Regulatory Division  
POA-1988-269-M6

**DEPARTMENT OF THE ARMY**  
**PERMIT MODIFICATION**

Department of the Army permit number POA-1988-269-M5, Hawk Inlet was issued to Hecla Green Creek Mining Company on January 9, 2015, to discharge of 253,000 cubic yards of fill material into 13.91 acres of wetlands for the following work:

Figure 1. Additional acreage request

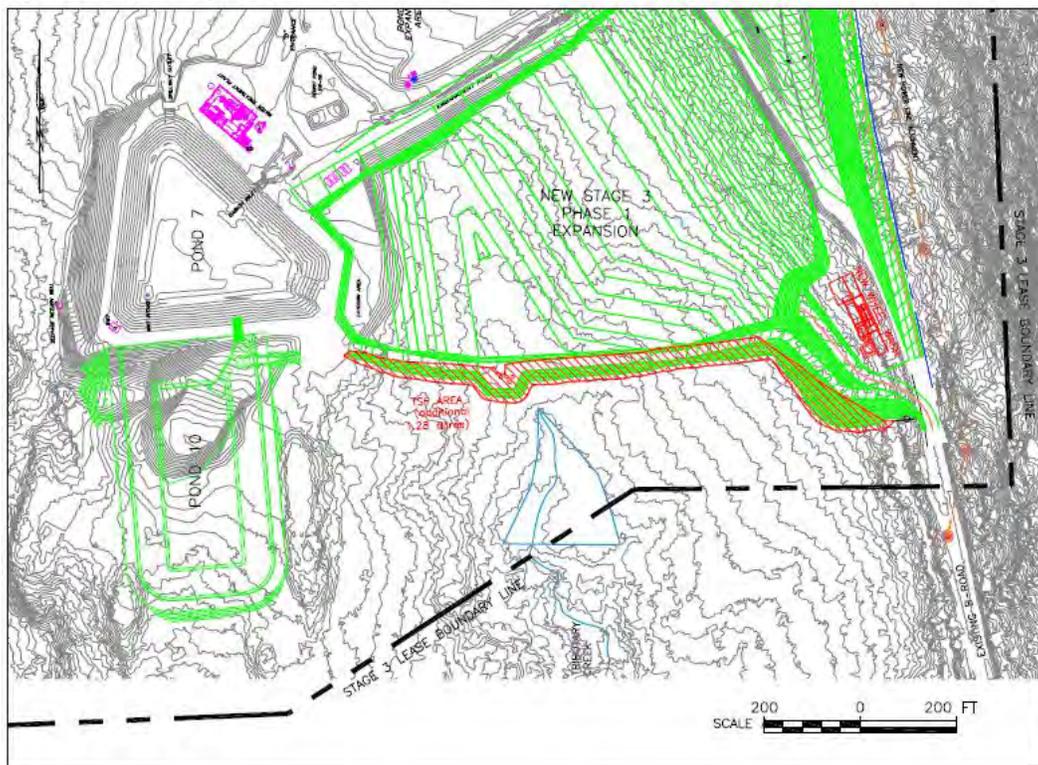
It was not until drafting the contract for timber clearing that HGCMC recognized the redesign had extended the southern boundary of the facility further into the adjacent wetlands. This was a result of switching the material for building the embankment road from construction rock to co-disposal of tailings and waste rock. With the redesign a collection ditch was added to the toe of the embankment road. To maintain the ditch and to have access to other infrastructure the embankment toe access road was extended from Pond 7 to the B-Road (Figure 1). It is this feature that results in the additional wetland impact.

The increase in wetland disturbance from the redesign is 1.28 acres (Table 1) of fen wetlands. To partially offset the additional wetland impact HGCMC will not construct Stock Pile H that impacts 0.69 acres of forested wetlands and scrub-shrub bog. By not constructing the stockpile the increase in wetland impact would be kept to 0.59 acres. The redesigned Stage 3 Expansion project will impact a

**AMENDED MITIGATION SITE MAP**

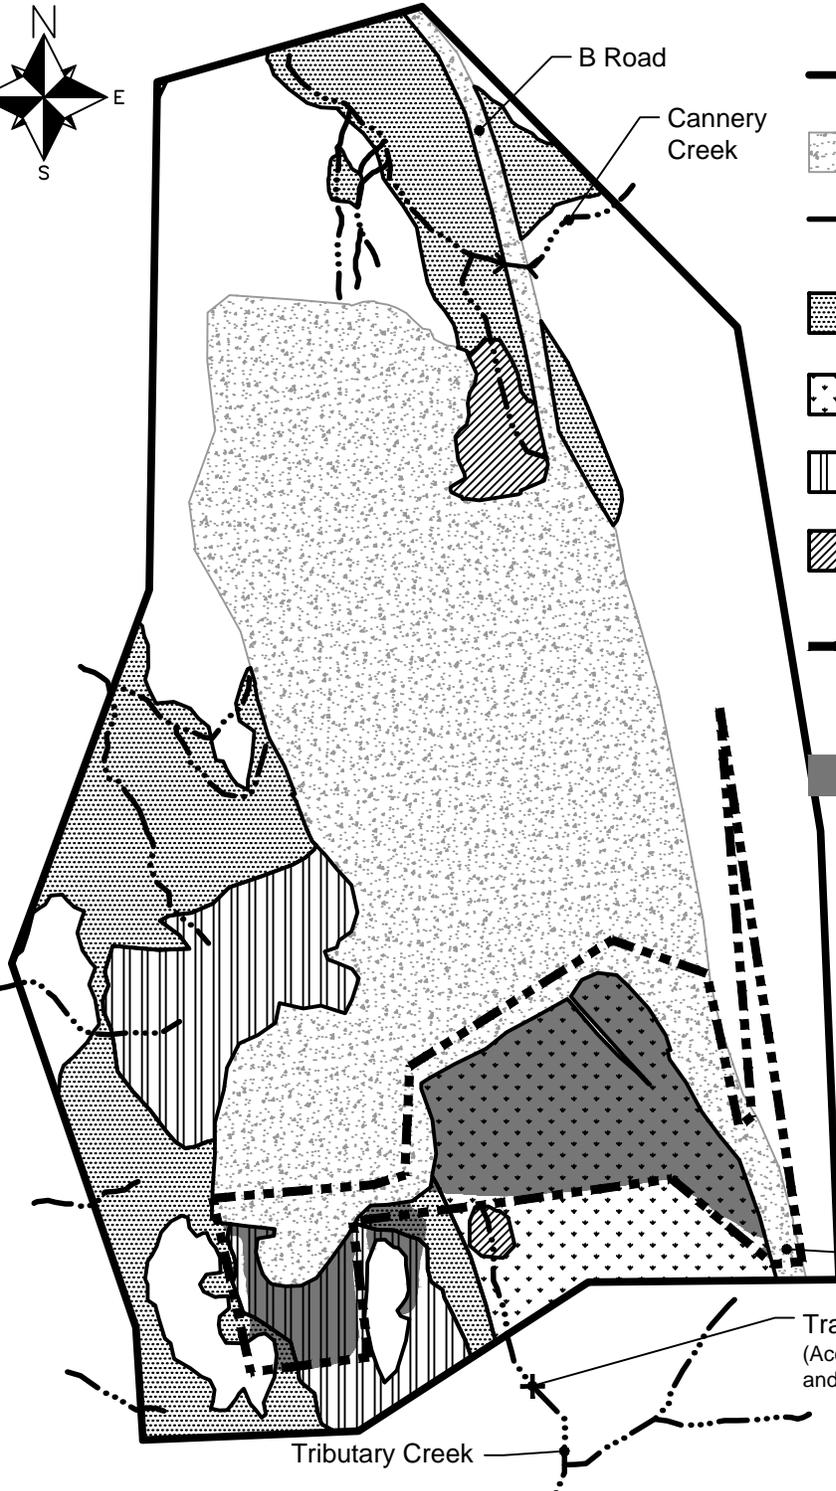
5. As compensatory mitigation, the permittee shall dedicate an additional 2.05 acres of bog/bog wetlands for a total of 53.65 acres of land of which 50.5-acres are wetlands, (identified on sheet 5 of 10, dated February 2015), into a conservation easement. The conservation easement shall be approved by the Corps of Engineers and recorded with the Juneau Recording District, including the drawing and legal description.

A map of the Nevada Creek mitigation site showing the additional 2.05 acres of mitigation is enclosed with this letter as an attachment. The entire mitigation site, including the additional acreage, totaling 53.65 acres is included in the executed Conservation Easement, which was provided in the current permit application.

PROJECT	TAILINGS STORAGE FACILITY STAGE 3 - PHASE 1 EXPANSION	
TITLE	TAILINGS STORAGE AREA GENERAL ARRANGEMENT	
SCALE	AS SHOWN	DWG. NO. D-64002

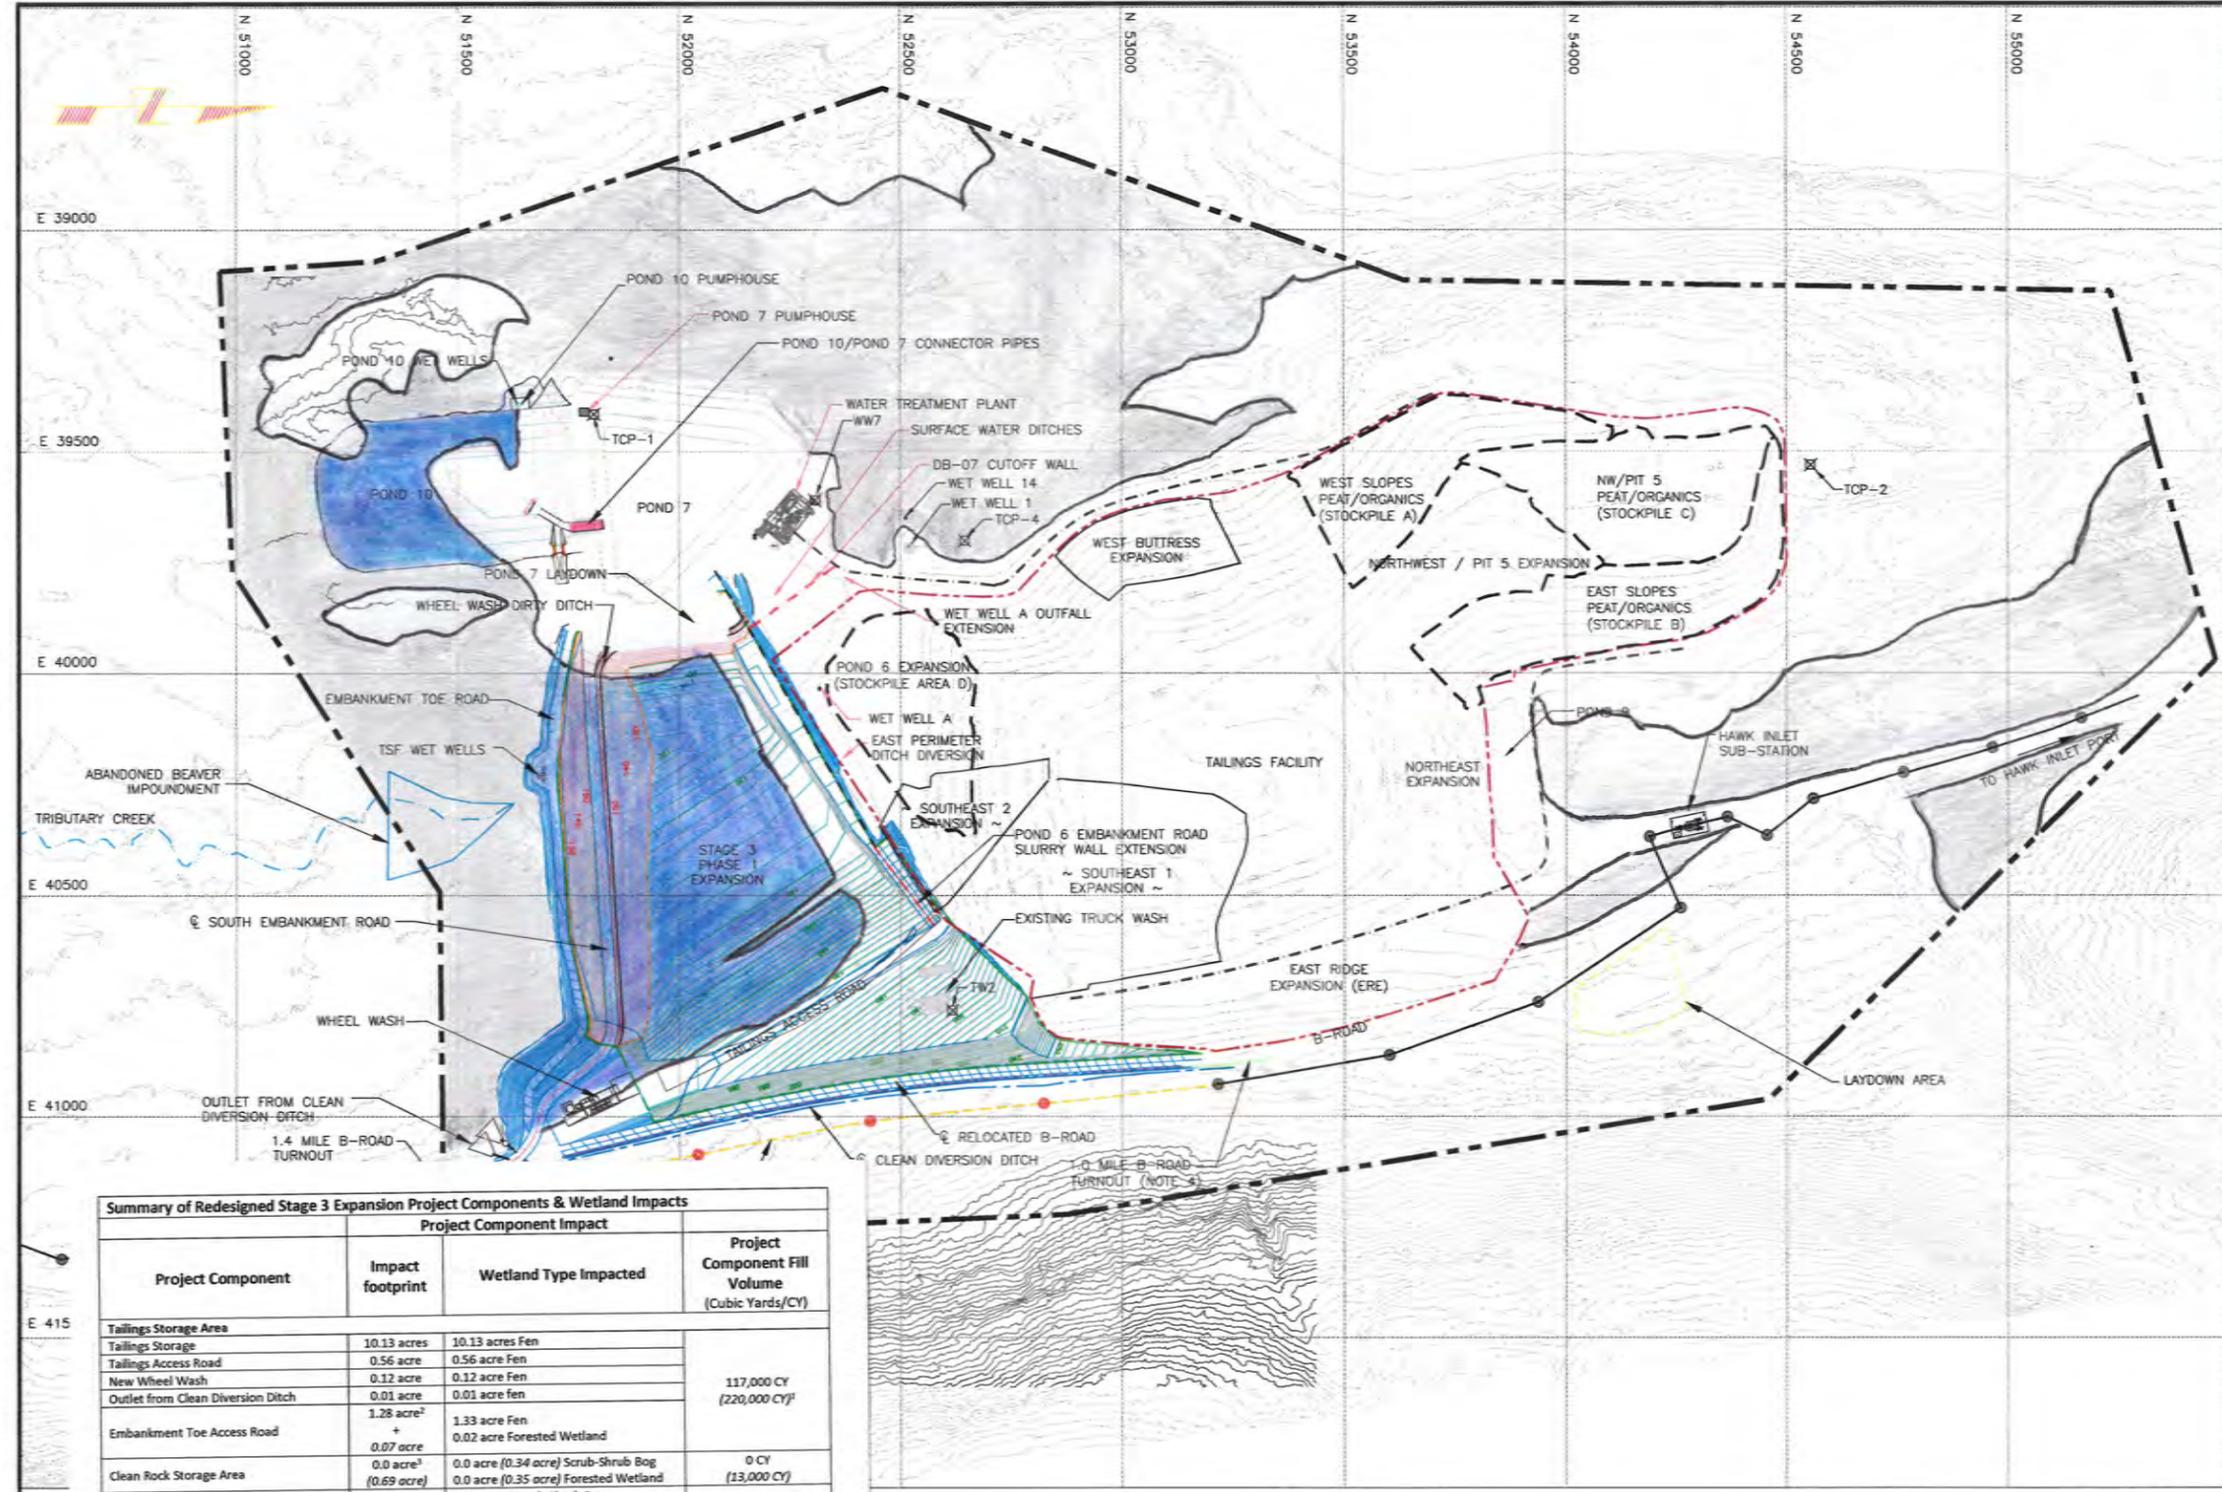
"This permit authorizes the placement of fill in an additional 1.28 acres of wetlands to increase the south side of the expansion area , (as shown on the attached plan (Sheet 4 of 10). This permit also modifies the original authorization with the removal of Stockpile H for a reduction of 0.69 acres of wetlands originally permitted. The total net increase of wetlands authorized by this modification is 0.59 acres of forested and scrub shrub wetlands."
